# REVIEW OF US FILTER CORPORATION SALTON RIVER PROPOSAL FINAL REPORT

March 2003

**Salton Sea Authority**

**Tetra Tech, Inc.**

**Figure 5. Conceptual Layout for North Lake Alternative.**

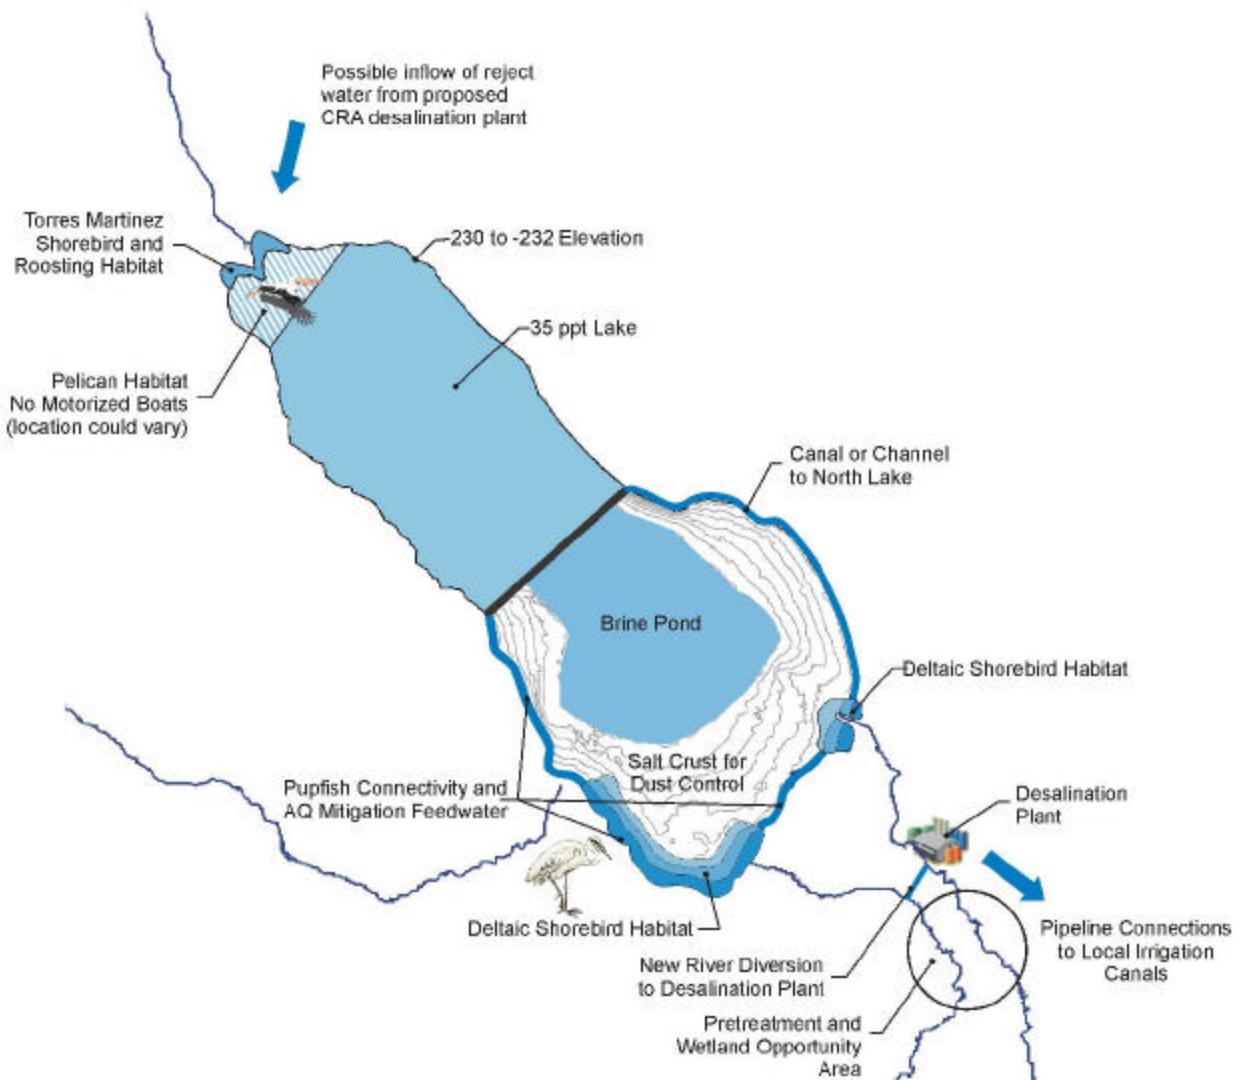
P. 34, Fig 5. While Variation 1 addresses a few bird habitat issues, key foraging and resting areas for all wading species in the south end of the Sea are not adequately addressed and only one of three key areas at the north end, the Whitewater Delta/Torres Martinez Shorebird and Roosting Habitat is addressed. The deltaic shorebird habitats at the south end of the Sea, and the Torres Martinez habitat plan at the north end as proposed in Variation 1 appear to be subject to the same physical conditions and to similar or perhaps even greater rates of encroachment by vegetation, as does the base proposal. The vast majority of breeding colonies of waterbirds are located at the south end of the Sea in patches of dead tree snags or on small islets isolated by water from the shoreline (see Fig. 4-6, Shuford et al. Avifauna of the Salton Sea). The loss of these sites that would apparently occur under Variation 1 is not considered by this proposal, nor is it adequately addressed by this review.

Figure 6. Conceptual Layout for Variation to the US Filter Proposal.

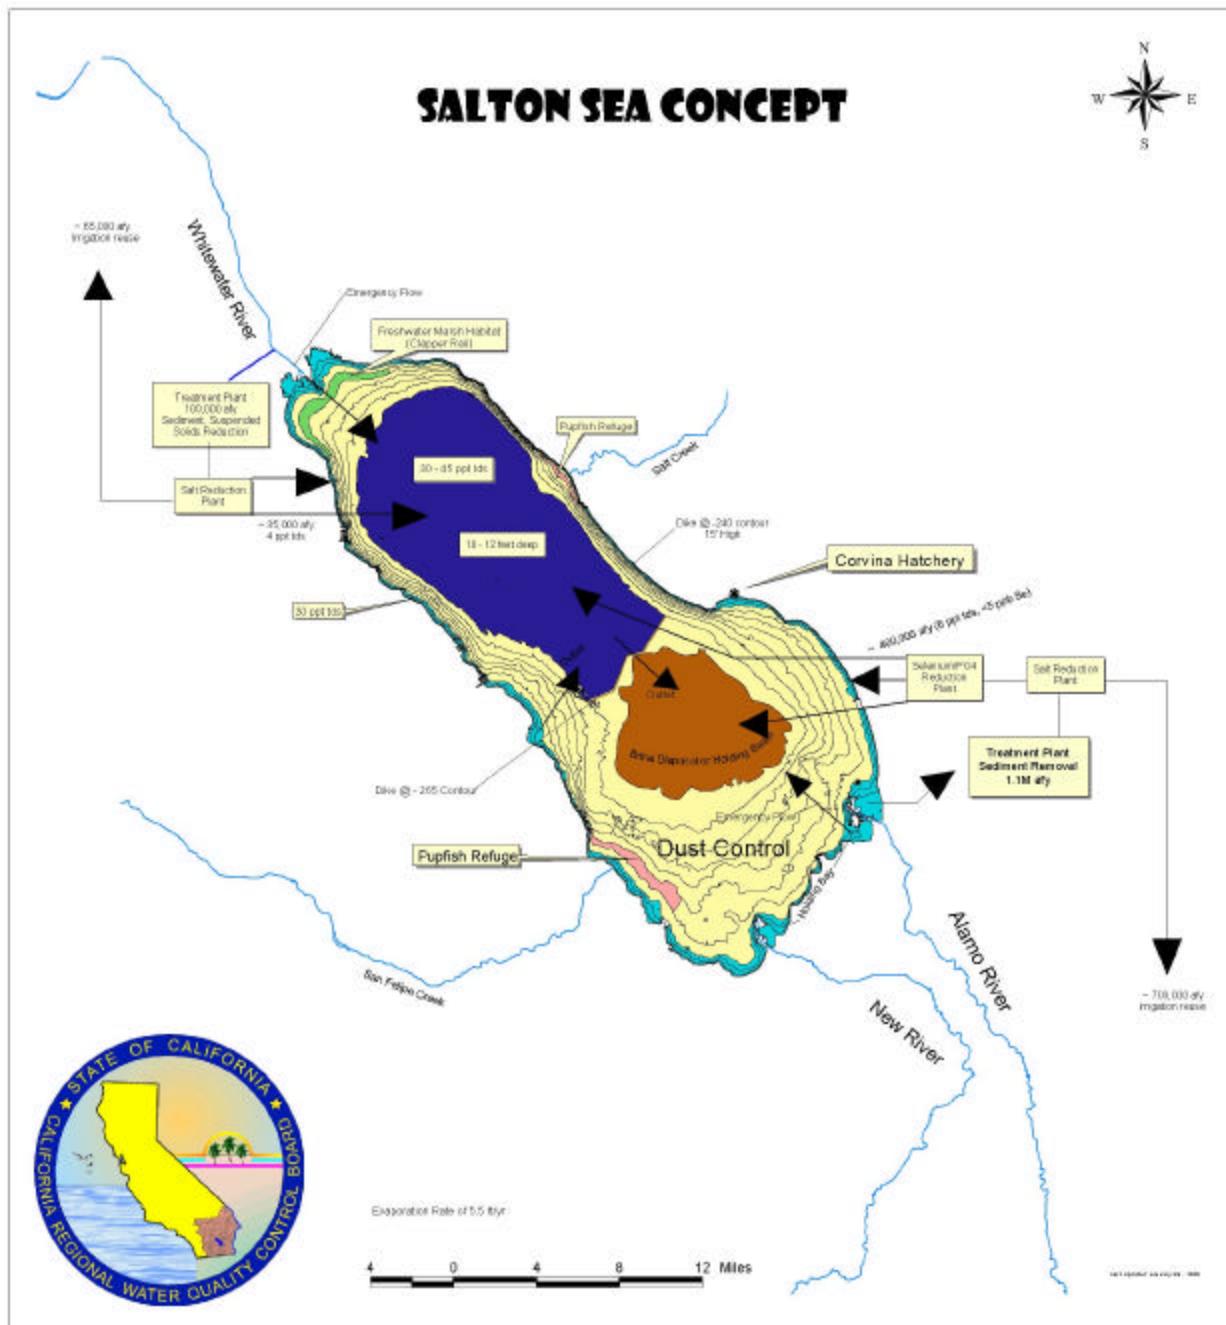
P. 39, Fig. 6- Variation 2. The retention of a marine environment in the central impoundment and in the Salton River impoundment may provide higher quality habitat for waterbirds and shorebirds, respectively, than those schemes proposed in the base and Variation 1 versions. However, from the information provided it is unclear how water depth could be effectively controlled in the narrow, peripheral band of the Salton River, to maintain adequate areas for shallowly flooded (0-10 cm of water) mudflats suitable for shorebird foraging and waterbird roosts. The loss of all existing breeding colony sites of waterbirds is not considered in this proposal (see Fig. 4-6, Shuford et al. Avifauna of the Salton Sea), and inadequately addressed by this review.
